ADDENDUM NUMBER ONE

**USC Health Sciences Renovation
Project No.: U-676-09**

State Permanent Improvement Project No.: H27-6052-AC

DATE OF ISSUE: October 31, 2013

8B REMOVABLE BOLLARD
C5.0 NOT TO SCALE

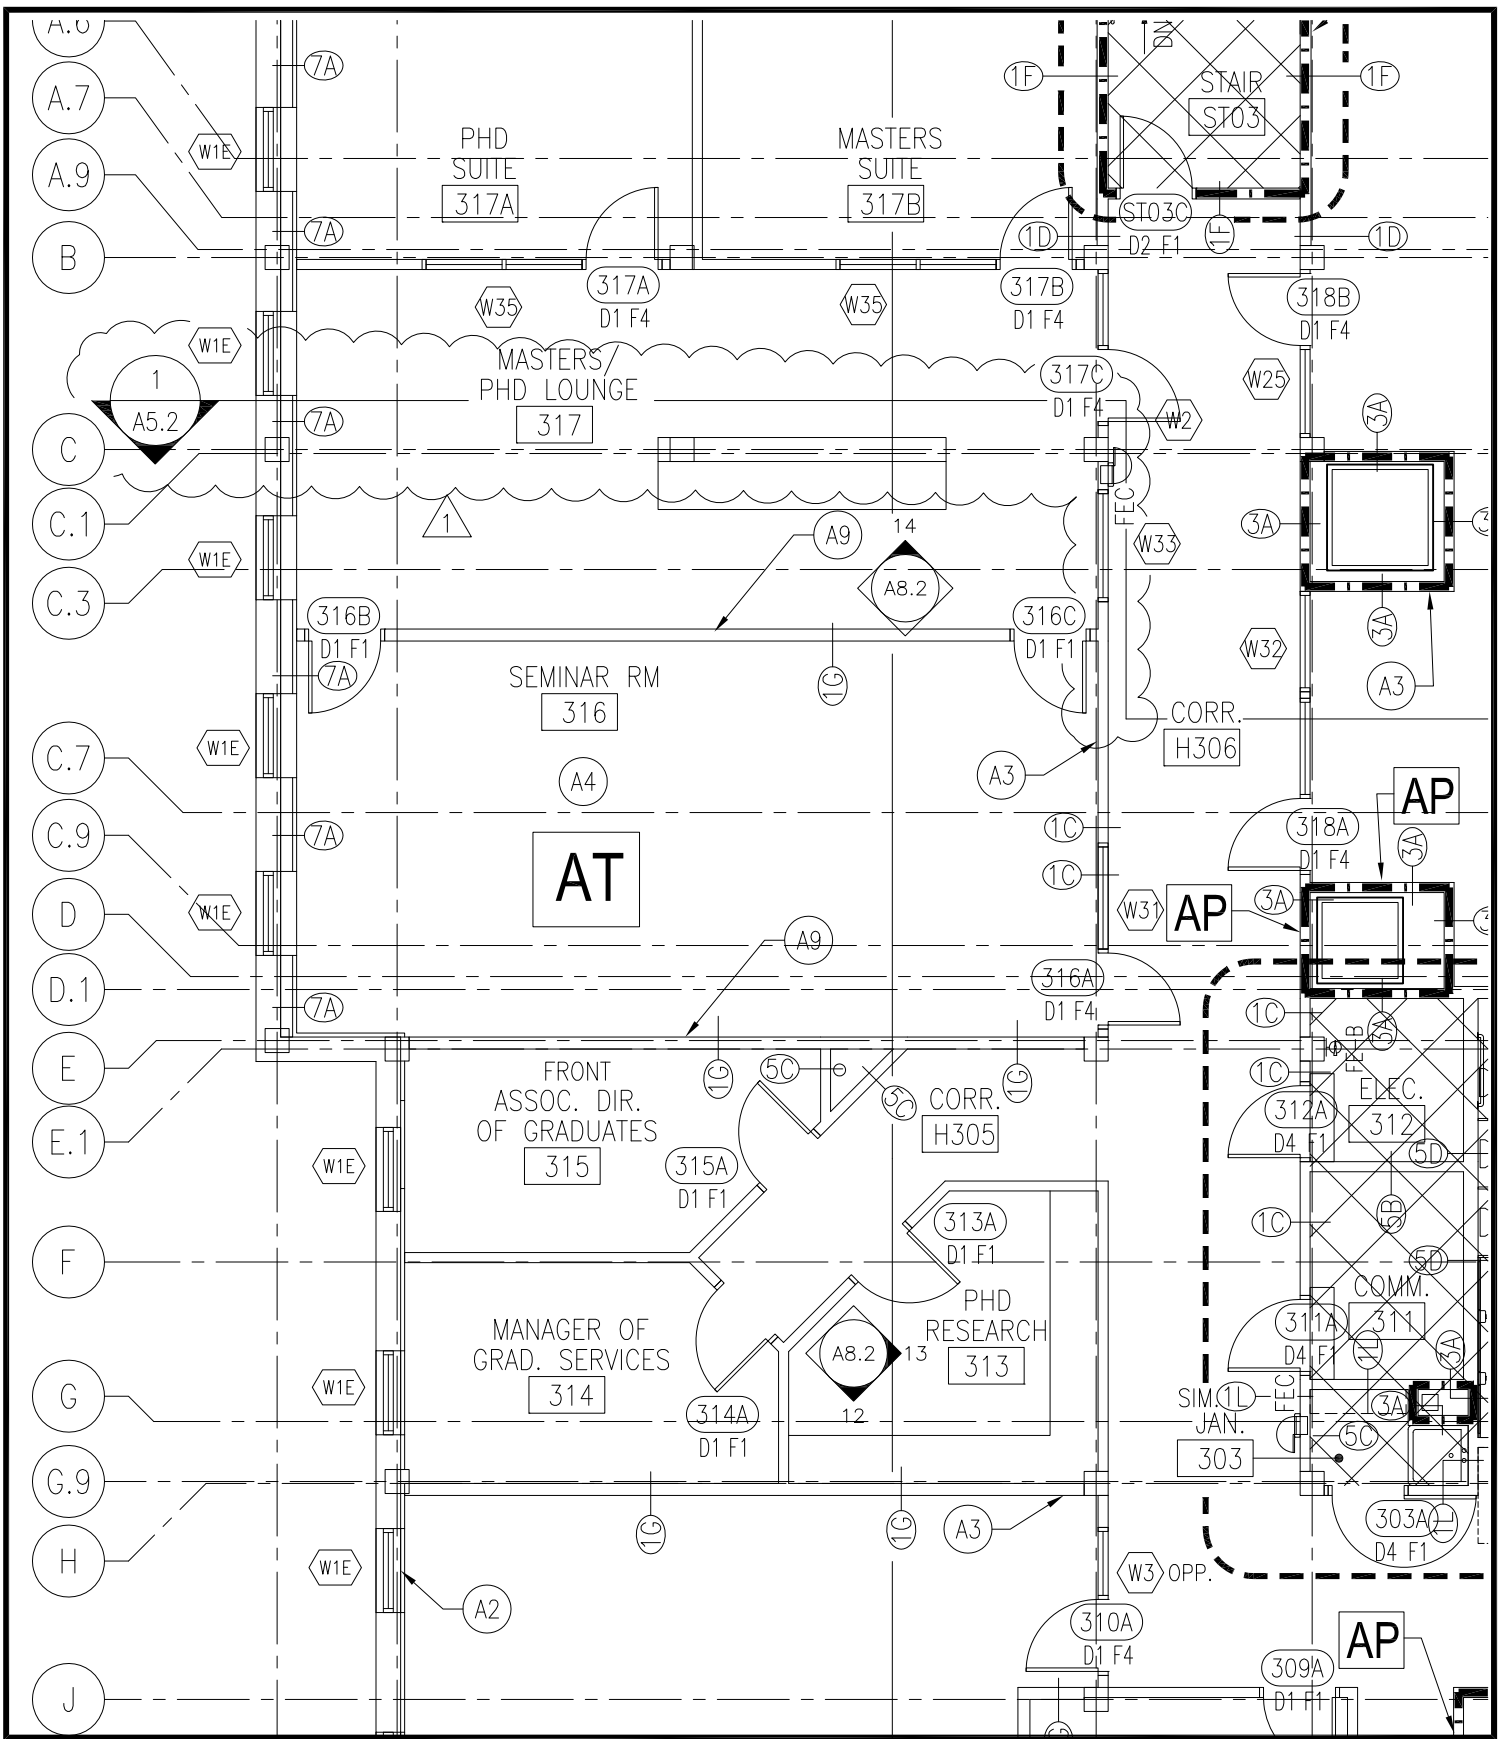
<u>Item No.</u>	<u>Description</u>
1.	<u>Revision:</u> Reference Drawing C5.0. Refer to detail 8B/C5.0. Indicate the pipe thickness for the removable bollard to be schedule 40. See attached SK-C-1

1. BOLLARDS TO BE BY FAIRWEATHER SITE FURNISHINGS, PORT ORCHARD, WA (800-323-1798) OR APPROVED EQUAL.
2. BOLLARDS TO BE POWDER-COATED BLACK.
3. INSTALL BOLLARD RECEIVER 1/4" BELOW FINISH GRADE TO ALLOW COVER TO BE FLUSH WITH FINISH GRADE.
4. PROVIDE SOLID BRONZE PADLOCK EQUAL TO WILSON BOHANNON #660 FOR ALL REMOVABLE BOLLARDS.
5. PROVIDE 6" RECEIVER COVER ACCESSORY.

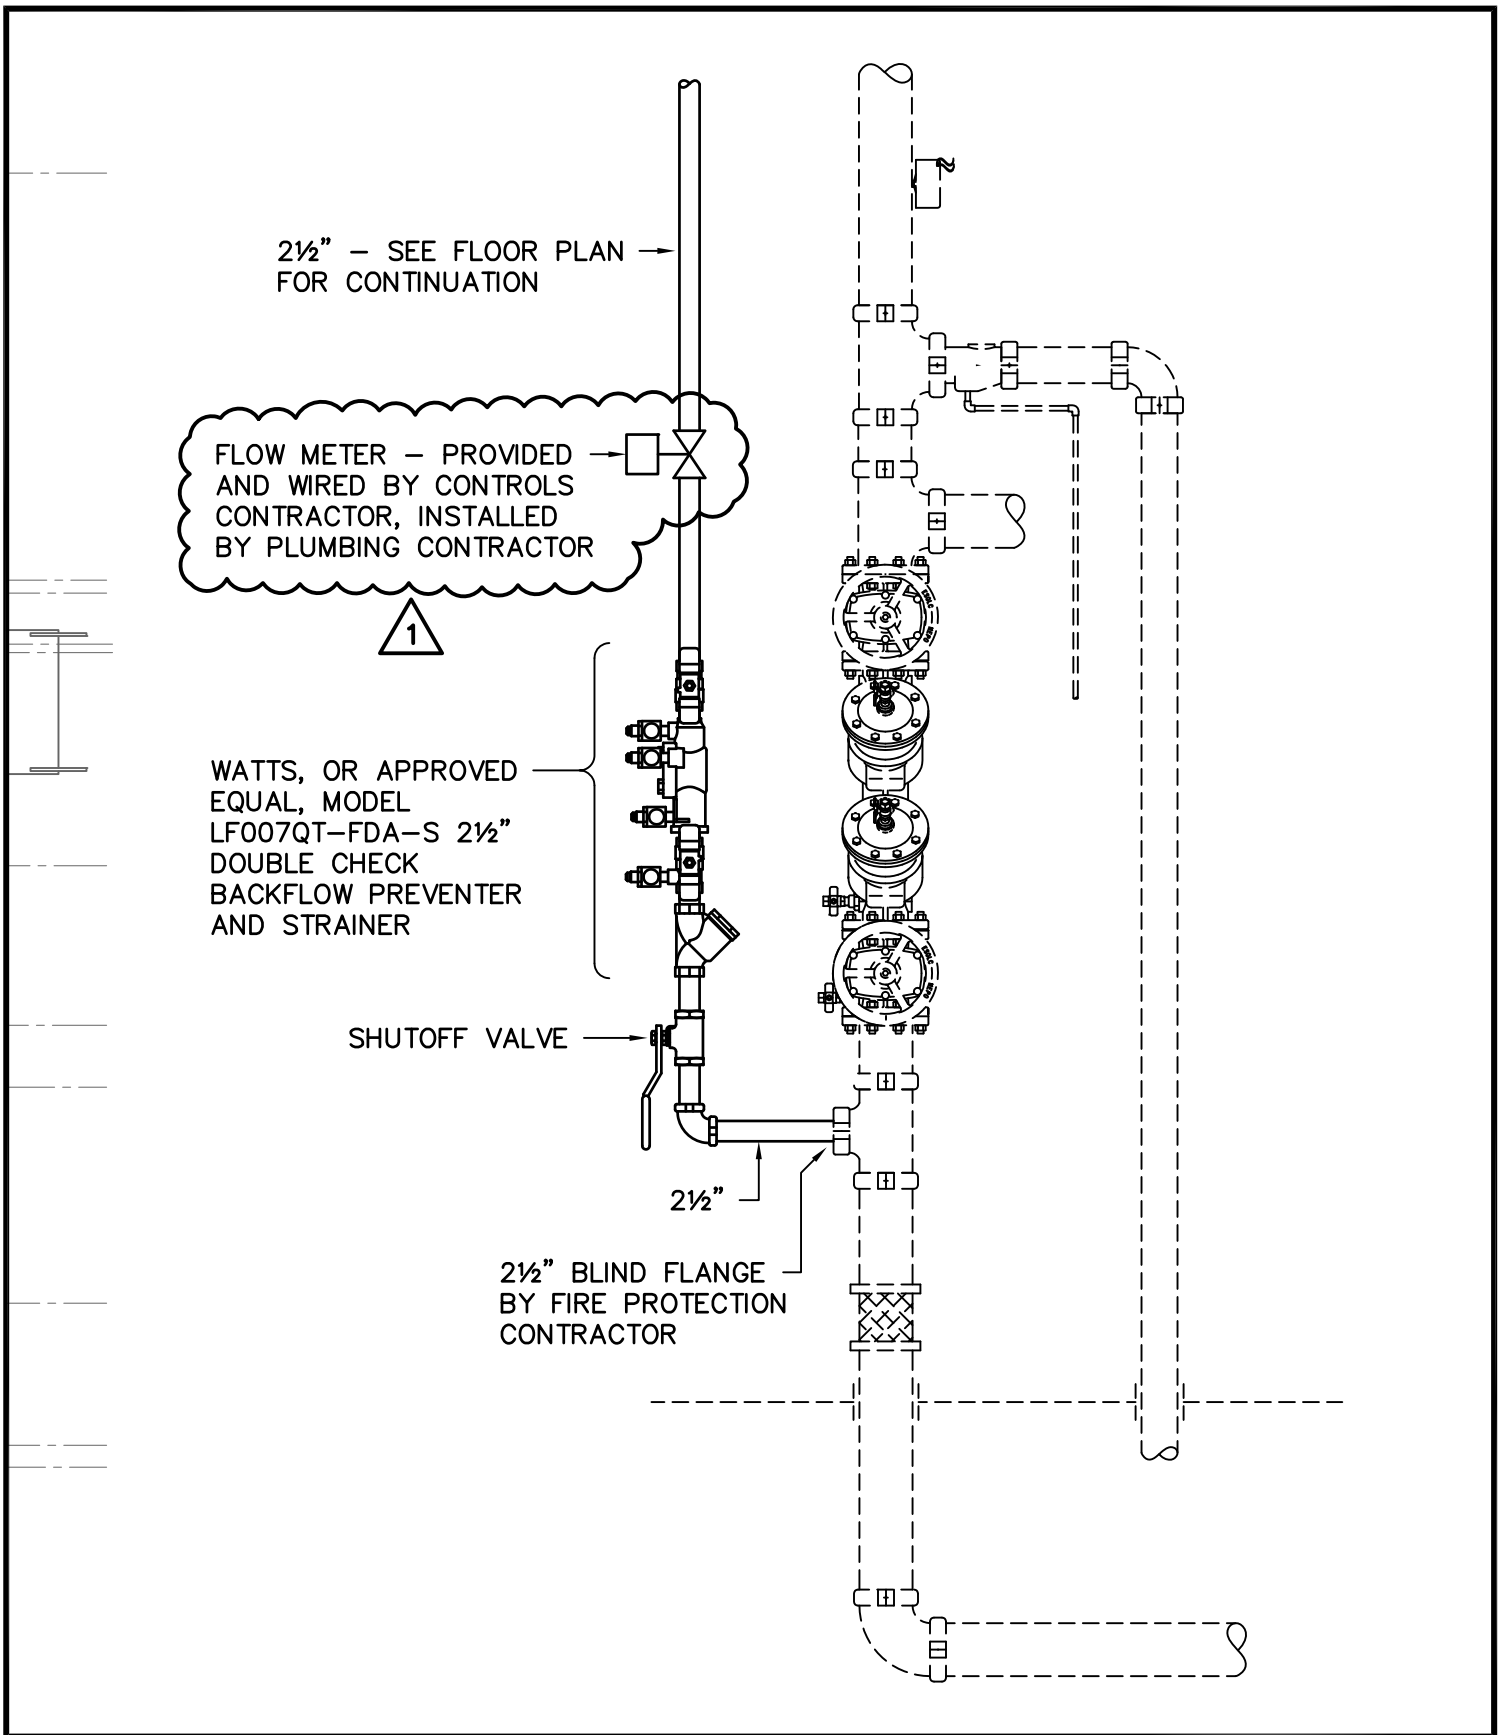
Refer to Sheet P2.1

Refer to the attached sketch, SK-P-1. This sketch adds the location of the flow meter, installed by the plumbing contractor, to the supply piping riser.
